U.S. Muon Accelerator Program Internal Review Report

Revision Date: May 11, 2015

MICE RF Module Engineering Design Readiness

Figure 1 The bypass line configuration shown requires only a single throttling valve and small pump for non-gettable gases. An alternative configuration might involve a dual setup, where the throttling valve and small pump attached to a spare port on each RF Module.

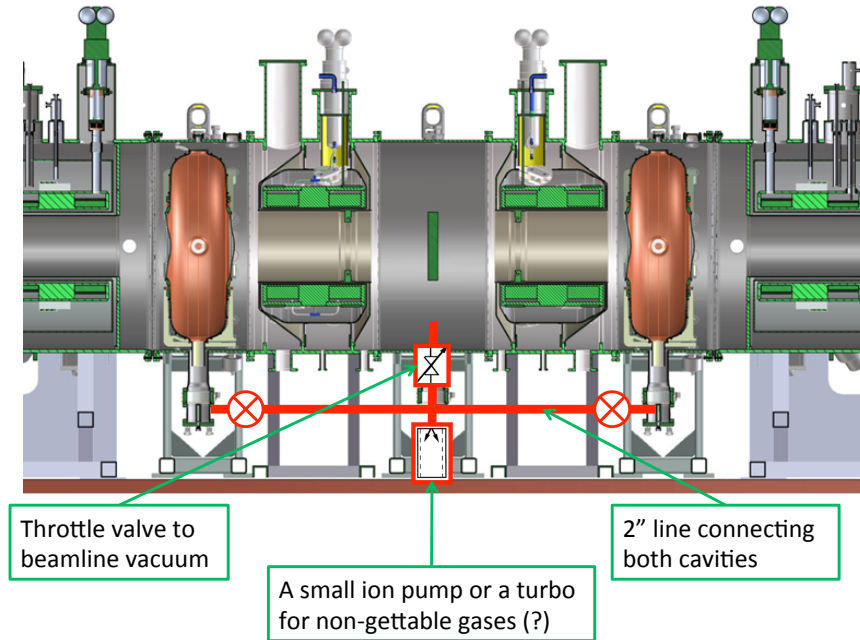
8. A fixed minimum conductance (arbitrarily proposed to be in the 3-10 L/s range) should be maintained in the bypass line between the cavity and outer vessel to protect against small fluctuations in the molecular flow regime and to provide pumping for non-gettable pumped gasses. A variable flow valve can be used in operations to increase the conductance above this minimum level. Figure 1 shows a potential system configuration for the bypass line.
